HISTORIC AND DESIGN REVIEW COMMISSION

HDRC CASE NO: 2024-271
ADDRESS: 254 E SUMMIT AVE
LEGAL DESCRIPTION: NCB 6885 BLK LOT 6, 7 & W 22.92 FT OF 8
ZONING: R-5, H
CITY COUNCIL DIST.: 1
DISTRICT: Monte Vista Historic District
APPLICANT: Don McDonald/Don b McDonald Architect
OWNER: Patricia Ruiz/NUNEZ-RUIZ ANA PATRICIA & RUIZ-HEALY PATRICIA FERNANDA
TYPE OF WORK: Carport construction
APPLICATION RECEIVED: July 19, 2024
60-DAY REVIEW: September 17, 2024
CASE MANAGER: Claudia Espinosa

The applicant is requesting a Certificate of Appropriateness for approval to install one (1) pergola like carport based on the following two options below:

A1.3
07/16/2024

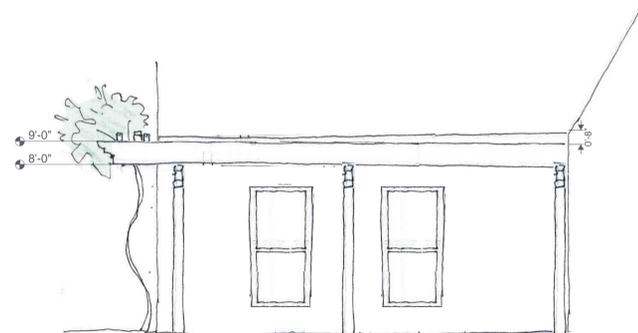
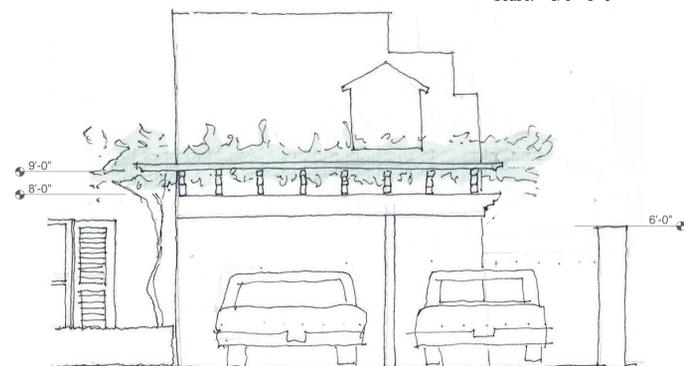
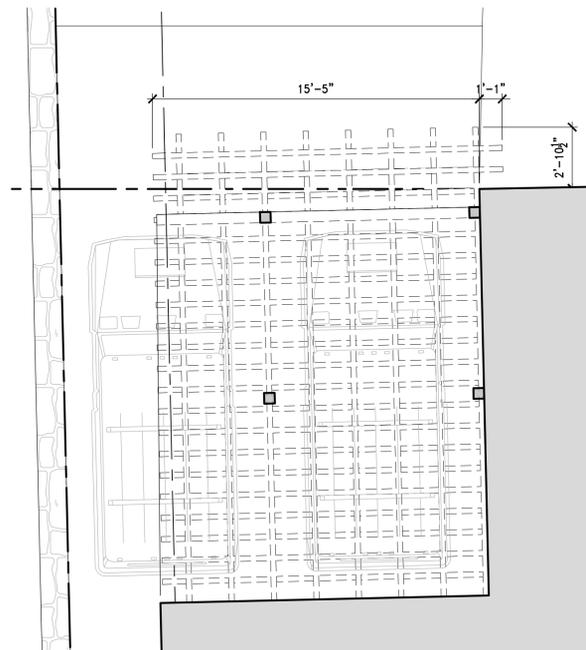
- b. CARPORT (OPTION 1)– The applicant requests approval to construct a 336-square-foot pergola-like carport with 6x6 metal posts and wood rafters, measuring 10 feet in height. The Guidelines for New Construction 5.A. notes that new garages and outbuildings should be visually subordinate to the primary historic structure in terms of their height, massing, and form, and should be no larger in plan than forty percent of the primary historic structure’s footprint. According to BCAD, the existing two-story primary structure on the lot features a footprint of approximately 5,200 square feet, including two porches, multiple living spaces, and a wood deck. The carport has a total footprint of 336-square-feet, or approximately 7% of the primary structure’s footprint. Staff finds the proposed footprint of the carport is generally appropriate.

- c. MATERIALS (FRAME) – The Guidelines for New Construction 5.A.iii and iv note that new accessory structures should relate to the period of construction of the primary historic structure on the lot through the use of complementary materials and simplified architectural details. The applicant proposes a pergola-like carport featuring 6x6 metal posts to be painted to resemble wood. Staff finds the proposed metal posts should be fully wood or clad in wood to conform to the guidelines.

- d. MATERIALS (ROOF) – The Guidelines for New Construction 5.A.iii and iv note that new accessory structures should relate to the period of construction of the primary historic structure on the lot through the use of complementary materials and simplified architectural details. The applicant proposes a pergola-like structure that features exposed rafters for the roof. Staff finds that the proposed roof material and form are appropriate.

- i. That the applicant proposes a wood or wood-clad frame for the carport, as noted in finding c and f.
- ii. That the stone wall not exceed 6 feet in height or remain at its current height base on finding h.
- iii. That the applicant meets all setback standards as required by city zoning and obtain a variance from the Board of Adjustment if applicable.

1 Floor Plan - Option 2

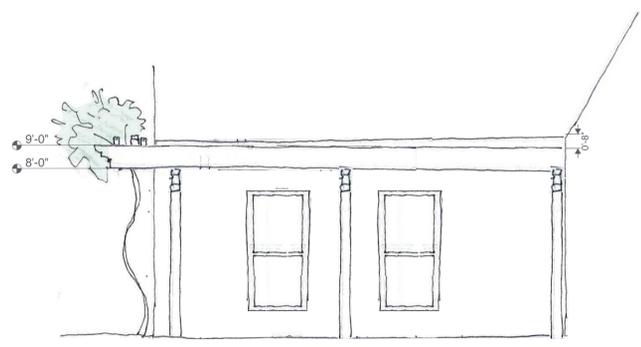
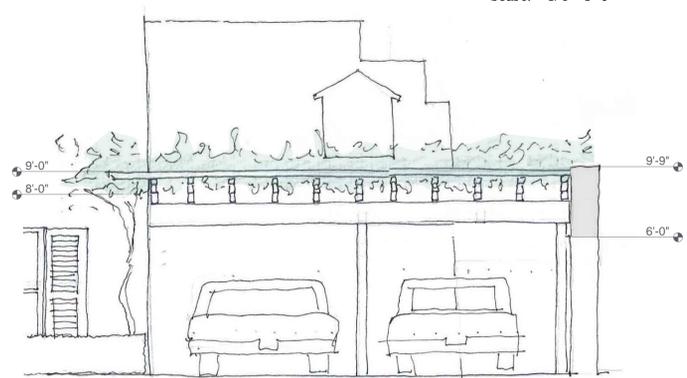
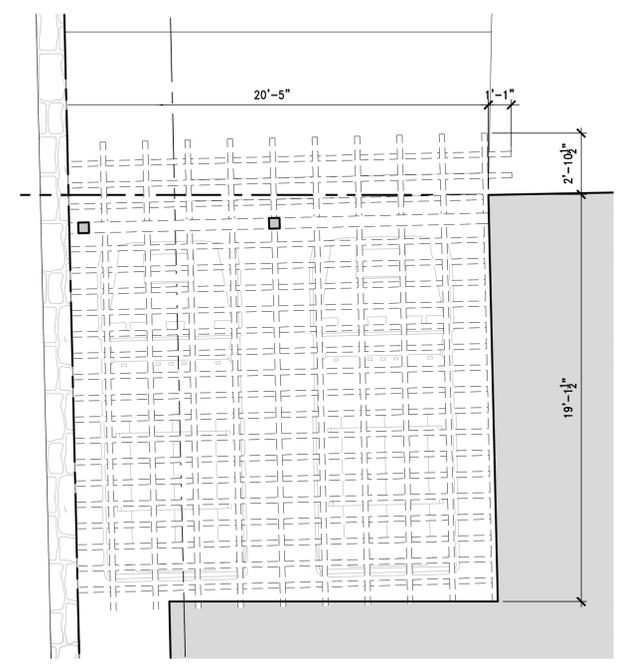
- e. CARPORT (OPTION 2)– The applicant requests approval to construct a 425-square-foot pergola-like carport with 6x6 metal posts and wood rafters, and a stone wall measuring approximately 4-foot in height. The Guidelines for New Construction 5.A. notes that new garages and outbuildings should be visually subordinate to the primary historic structure in terms of their height, massing, and form, and should be no larger in plan than forty percent of the primary historic structure’s footprint. According to BCAD, the existing two-story primary structure on the lot features a footprint of approximately 5,200 square feet, including two porches, multiple living spaces, and a wood deck. The carport has a total footprint of 425-square-feet, or approximately [8%] of the primary structure’s footprint. Staff finds the proposed footprint of the carport is generally appropriate.

- f. MATERIALS (FRAME) – The Guidelines for New Construction 5.A.iii and iv note that new accessory structures should relate to the period of construction of the primary historic structure on the lot through the use of complementary materials and simplified architectural details. The applicant proposes a pergola-like carport featuring 6x6 metal posts to be painted to resemble wood. Staff finds the proposed metal posts should be fully wood or clad in wood to conform to the guidelines.

- g. MATERIALS (ROOF) – The Guidelines for New Construction 5.A.iii and iv note that new accessory structures should relate to the period of construction of the primary historic structure on the lot through the use of complementary materials and simplified architectural details. The applicant proposes a pergola-like structure that features exposed rafters for the roof. Staff finds that the proposed roof material and form are appropriate.

- h. MATERIALS (STONE WALL) – The applicant has proposed to add 4 feet in height to an existing stone wall on the west side of the property line. At this time, there is an existing stone wall on the west side of the property line and the newly proposed wall will be an addition to the wall to accommodate the larger structure. Guidelines for Site Elements 2. B. iii, states to limit the height of new fences and walls within the front yard to a maximum of four feet. The appropriateness of a front yard fence is dependent on conditions within a specific historic district. New front yard fences should not be introduced within historic districts that have not historically had them. If a taller fence or wall existed historically, additional height may be considered. The height of a new retaining wall should not exceed the height of the slope it retains. The existing wall has historically been placed along the west side of the property line. Staff finds that adding additional height to the existing stone wall does not conform to the guidelines and exceeds the proposed height requirements.
